UTILITY PLAN
SCALE - 1" = 50'-0"

SOUTHLAKE VILLAGE
DICK BRABHAM ARCH 15

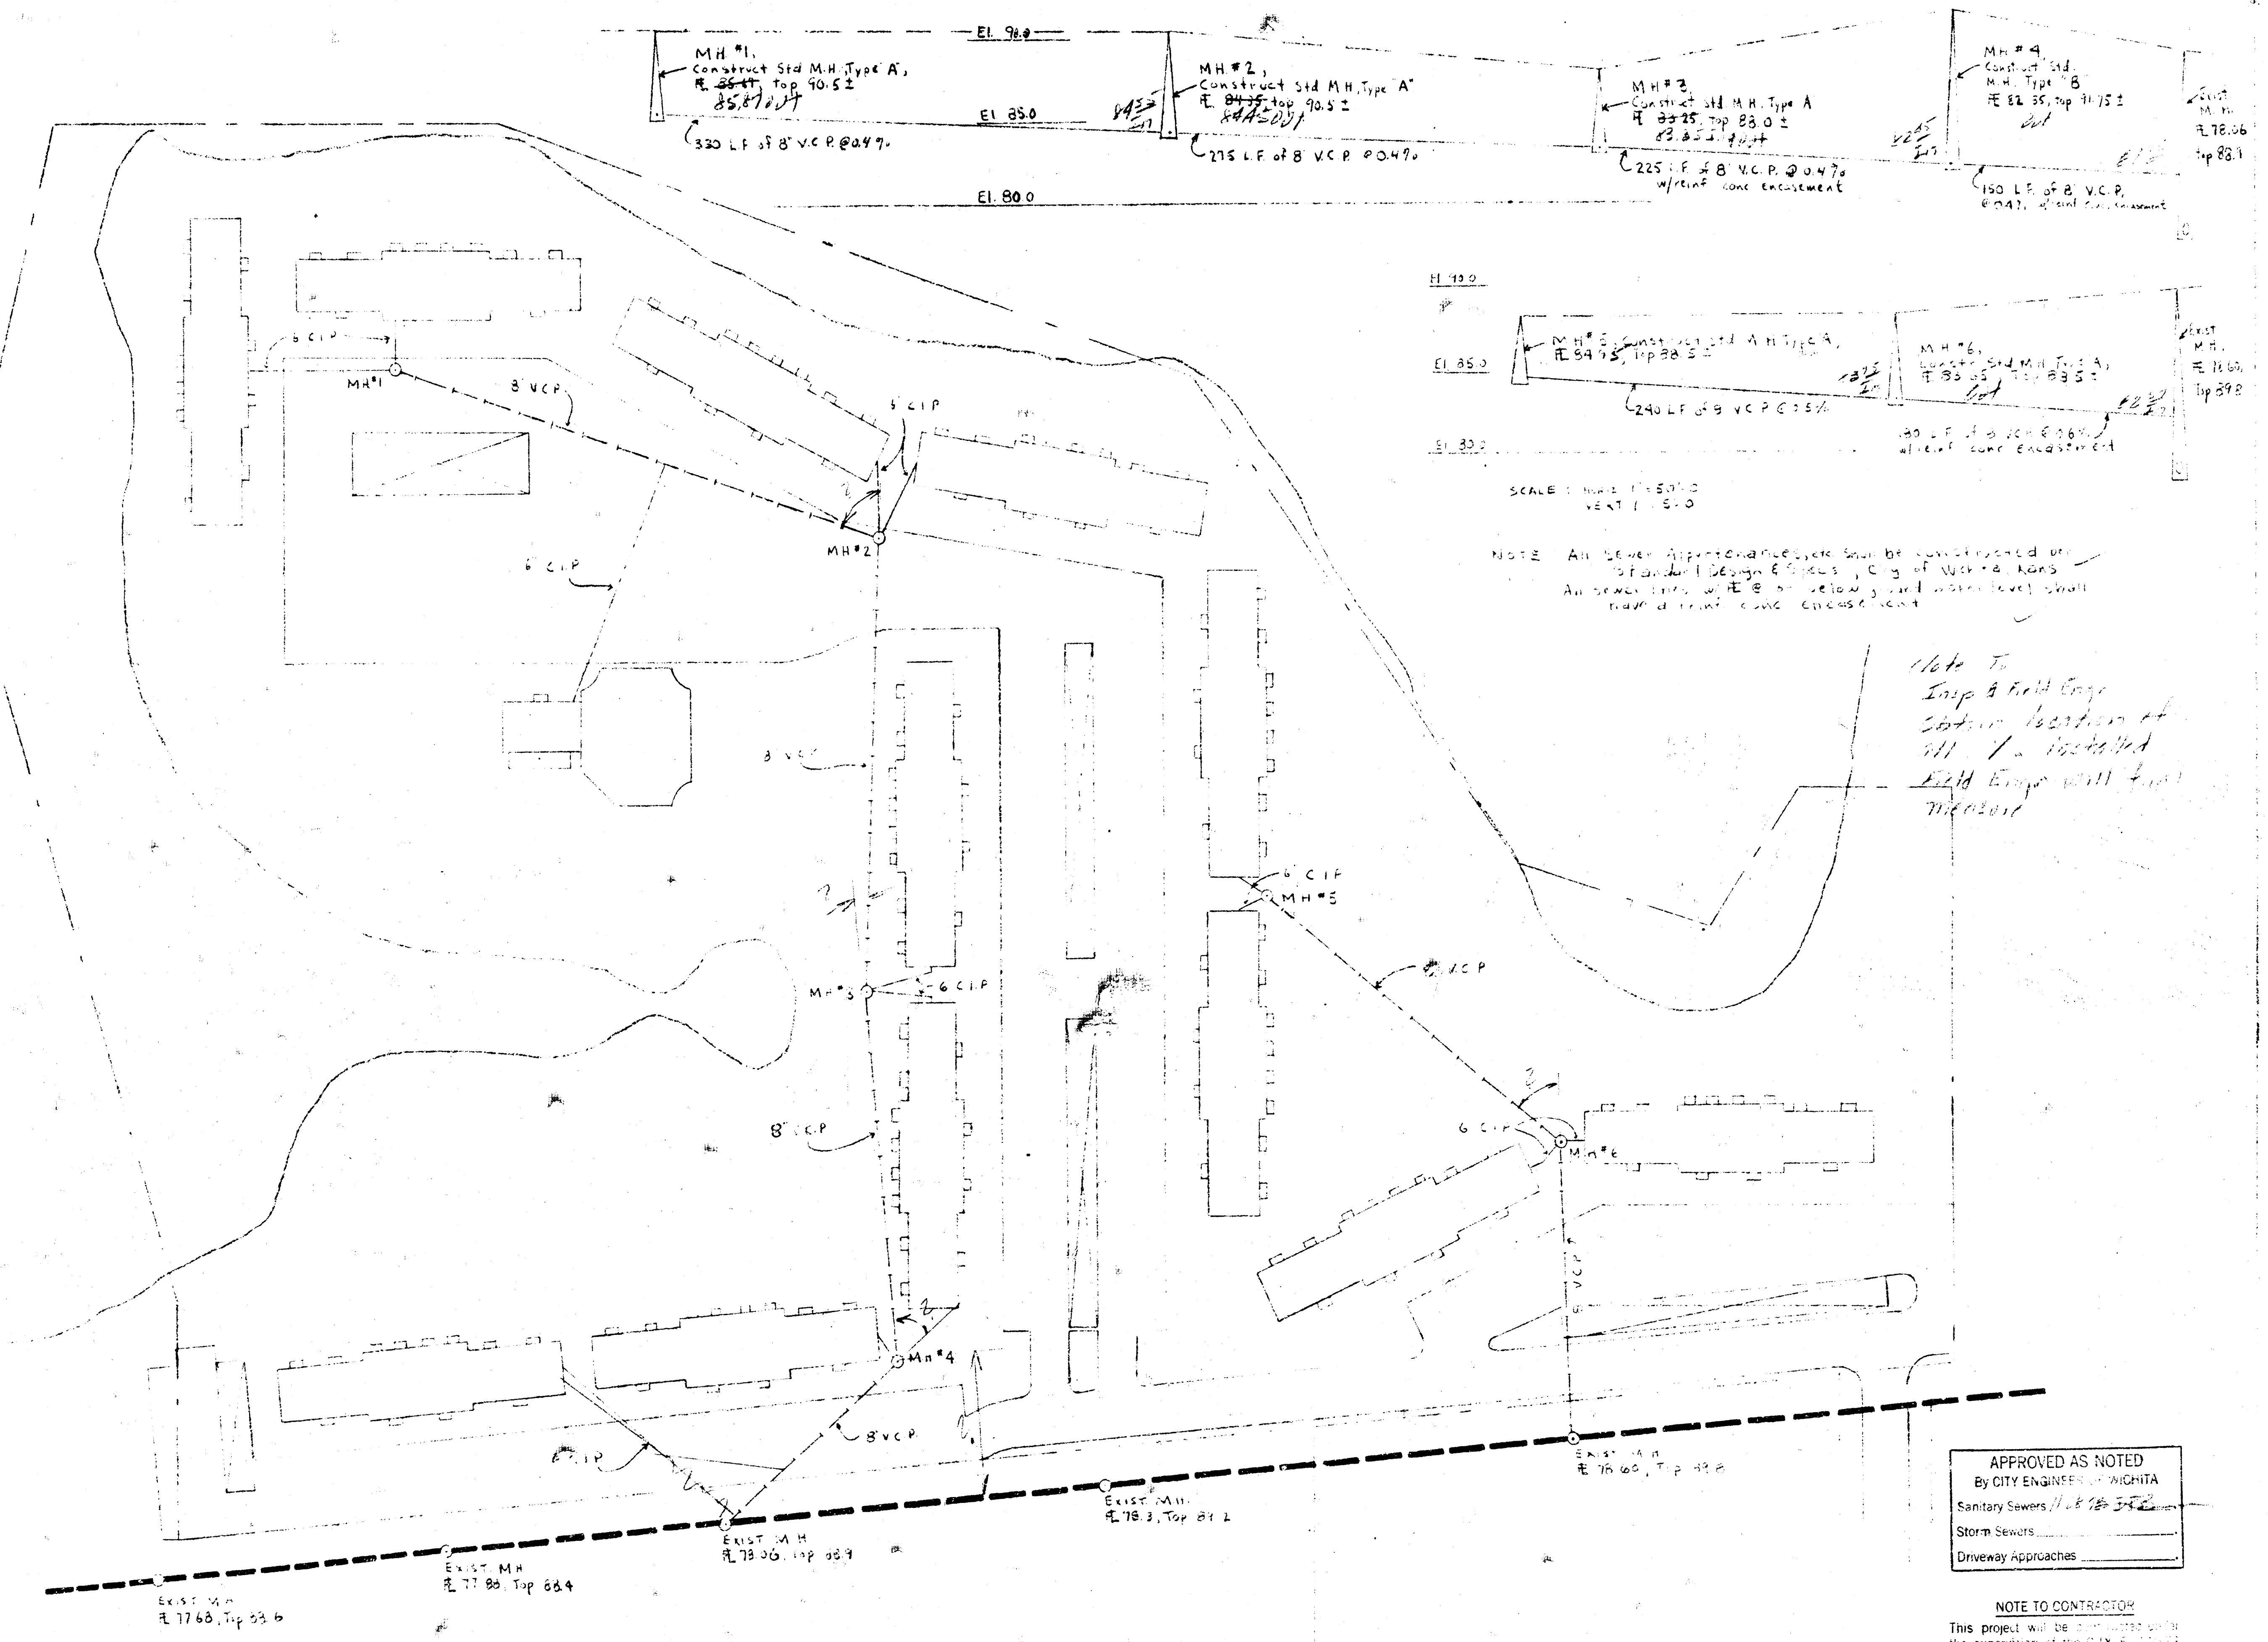
Note To
Imp & Field Engs
Slightly location of
all 1\"/>

APPROVED AS NOTED
By CITY ENGINEER WIGHTA
Sanitary Sewers 11/18/52
Storm Sewers
Driveway Approaches
